Agenda Item:		650-1091
Title:	Update Fixed Roof Definitions	
Date:	05/16/22	
Contact:	Name:	R. Austin Pace
	Company:	Consolidated Fabrication and Constructors
	Phone:	219-746-4944
	E-mail:	Austin@Consfab.com
Purpose:	Add a clear definition for self-supported roofs.	
Source:	Inquiry	
Revision:	2	
Impact:	The business impact of this item is neutral	
Rationale:	<p>In INQ-650-D117 the inquirer wanted to know if self-supported cone roofs with rafters not welded to the roof plates and without a center column can be designed using the formulas from 5.10.5 for self-supported cone roofs. The answer is NO. The minimum thickness formulas in 5.10.5.1 are strictly for self-supported cone roofs supported only by the roof plates themselves. Any cone roofs which are supported by rafters or any other means need to be designed to 5.10.4. Similarly, the formulas for dome & umbrella roofs in 5.10.6.1 are strictly for dome & umbrella roofs supported only by the roof plate.</p>

Figure V.1a—Dimensions for Unstiffened Self-Supporting Cone Roof

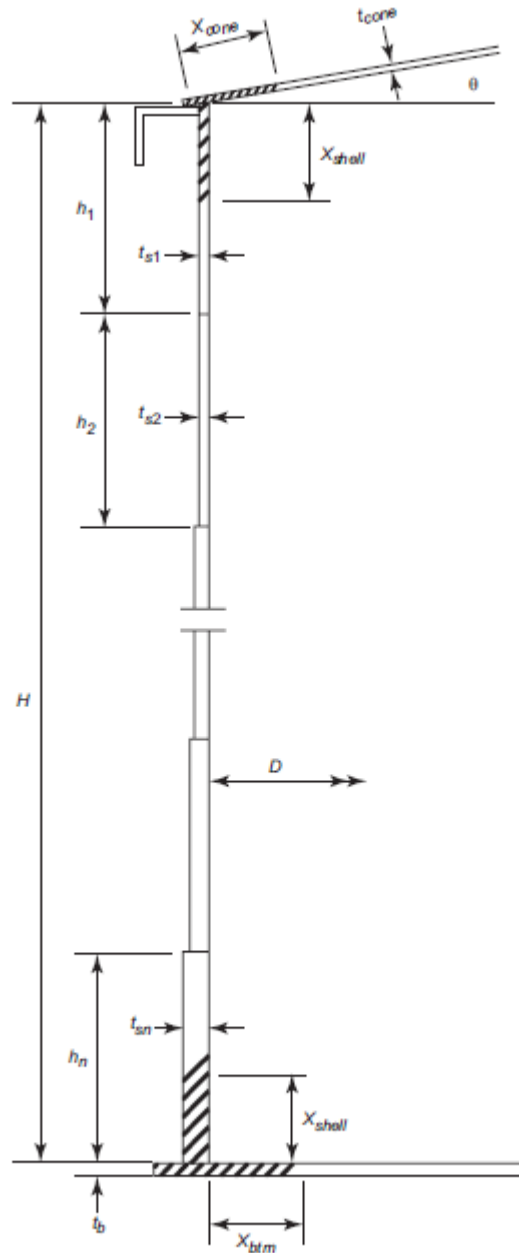
V.7.2 Unstiffened Self-Supporting Cone Roof

NOTE See Annex F, Figure F.2 for alternative configurations and associated limitations on structural section used for top stiffener.

Figure V.1b—Dimensions for Unstiffened Self-Supporting Dome Roof

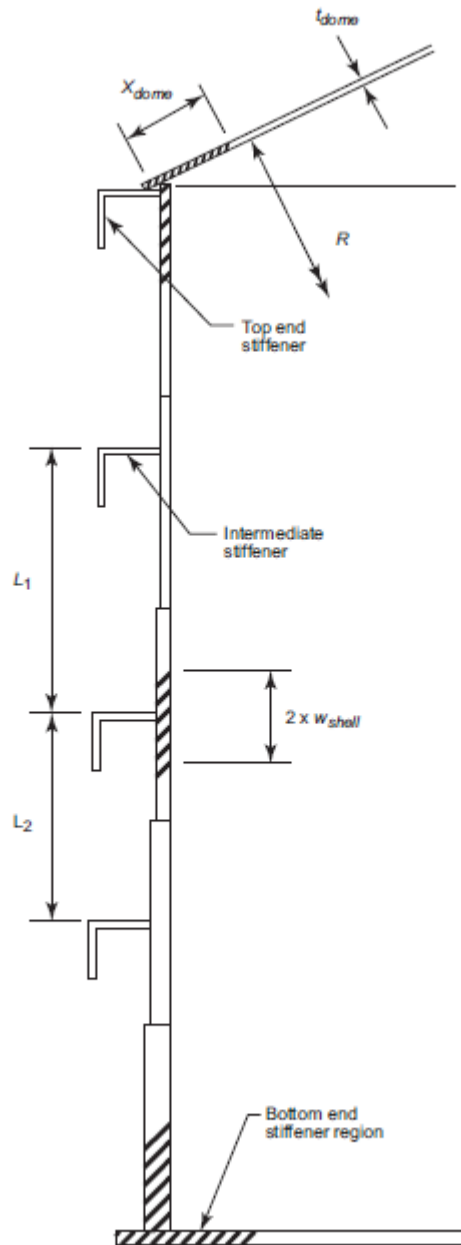
V.7.3 Unstiffened Self-Supporting Dome or Umbrella Roof

NOTE See Annex F, Figure F2 for alternative configurations and associated limitations on structural section used for top stiffener.
